Subject: PPSSTH-138 - Council Reference RA21/1003 – 41 Main Rd, CAMBEWARRA - Lot 4 DP 542936 - Staged residential subdivision to create 256 Torrens Title allotments and provision of associated civil infrastructure and landscaping

Council provides the following addendum to the submitted assessment report, addressing the matters raised in the determination meeting on 7 March 2023.

Figure 1 – Existing 1% AEP Flood hazard (left) and Proposed 1% AEP hazard showing changes to stock escape routes in 1% AEP (right)

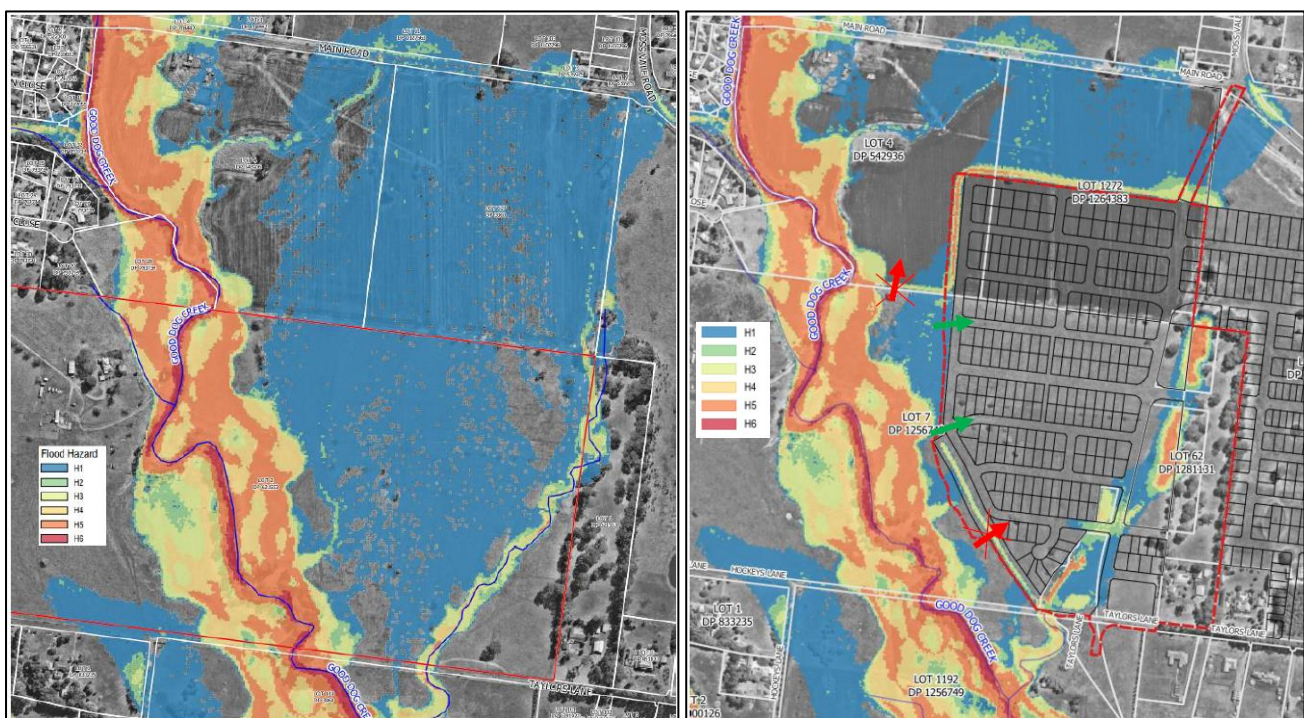
- All lots and roads of the subdivision will be constructed above the year 2100 scenario 1% Annual Exceedance Probability (AEP).
- No residential lots will be flood impacted during a PMF event. Some internal roads will be impacted by shallow (often < 0.15m deep) flood water during a PMF event which corresponds with a H1 (Generally safe for vehicles, people and buildings) hazard category.

To summarise, Council is satisfied that the proposed subdivision does not introduce an unacceptable level of flood risk to future residents. The proposed mitigation measures, such as filling of the land and on-site detention, in combination with proposed development conditions of consent are considered appropriate to adequately mitigate the flood risk to an acceptable level for future residents and adjacent land in accordance with Council's guidelines and the NSW Floodplain Development Manual. All lots are above the PMF level and can, as such, not be inundated by riverine flooding. In an extreme flood event, the subdivision may become isolated for a period of time as regional and local roads are inundated.

The figures below show the pre- and post- flood extent. Although some of the land is flood impacted, Condition 42(a) of the updated draft determination has been imposed to ensure all roads are flood-free during a 1% AEP event.

- Emergency access during the year 2100 scenario 1% AEP flood event will be achieved via Taylors Lane and Moss Vale Road through already approved subdivisions on land to the east, being SF10804 and SF10895. This has been conditioned. Refer to Condition 42(c) of the updated draft determination.

Figure 2 – Change in 100 year ARI Water Level
Source: On-Site Detention Memo, Maker ENG (October 2022)

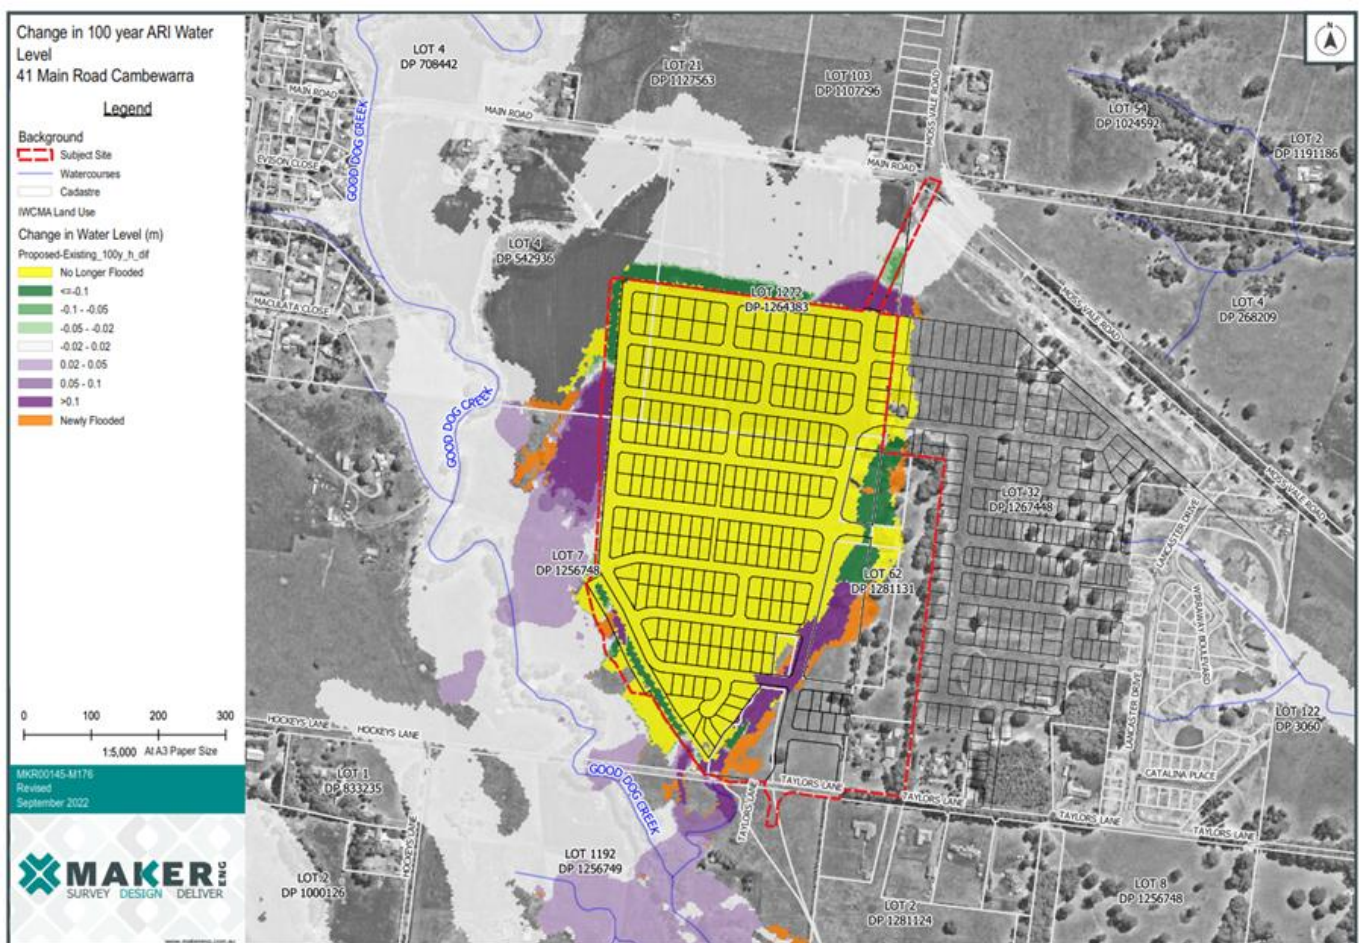
'The subject site currently consists of flood prone land and is proposed to be filled to become flood-free. The hazard and hydraulic category of the existing site is Low Hazard Flood Fringe. As per the NSW Floodplain Development Manual, development of Flood Fringe areas will not have any significant effect on the pattern of flood flows and/or levels in the floodplain. The reason for this is that it does not convey significant volumes of water during floods nor is it an important area for the temporary storage of floodwater during the passage of a flood.'

It has been demonstrated through flood modelling that the proposed filling of the site does not adversely impact adjacent properties and/or land within the floodplain. The proposed fill is therefore unlikely to have a significant cumulative impact within the floodplain due to the existing Low Hazard Flood Fringe classification of the local flood conditions.'

Figure 2 below identifies that no unacceptable levels of afflux is reported on adjacent properties as a result of the filling.

Figure 3 – Retaining Wall Structure
Source: Drawing MKR00145-10-C016, Maker ENG

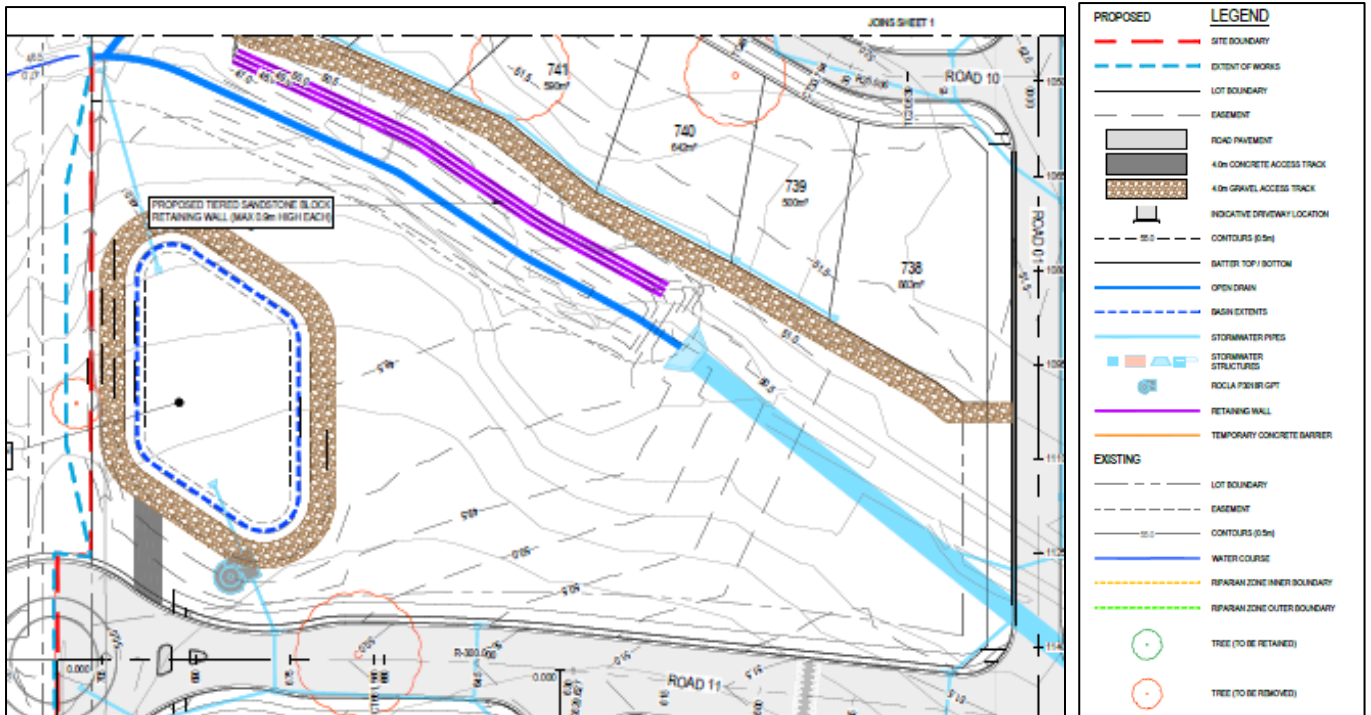
Retaining walls are proposed between the private property and the swales within the south-west corner of the site (Refer to drawing MKR00145-10-C016 at Figure 3 below). Council's City Services typically do not accept retaining walls for maintenance and liability reasons. However, Council's Development Engineer has advised that the walls could not be easily replaced in this location with a batter given that they are 2-3m high and adjacent to the stormwater swale. Note the total height of fill retained by the retaining walls is approximately 2.8m and the height of each wall is approximately 0.9m in height.

Alternatively, a planted steep batter or relocation of the swale would be required in this location to replace the retaining walls, reducing the area of open space available and may result in hydraulic design issues with the swale.

With consideration of the above, Council considers that the proposed tiered sandstone blocks in this location are acceptable given they are acceptably maintenance friendly and that they will be gravity walls with sandstone blocks and therefore will also be highly durable.

This matter has been conditioned, requiring further details of the landscaping and fencing treatment for the tiered sandstone block wall, to be provided as part of amended landscaping design plans and specifications, and approved by the Director of City Development or their delegate at Council prior to the issue of a Subdivision Works Certificate. Refer to Condition 41 of the updated draft determination.
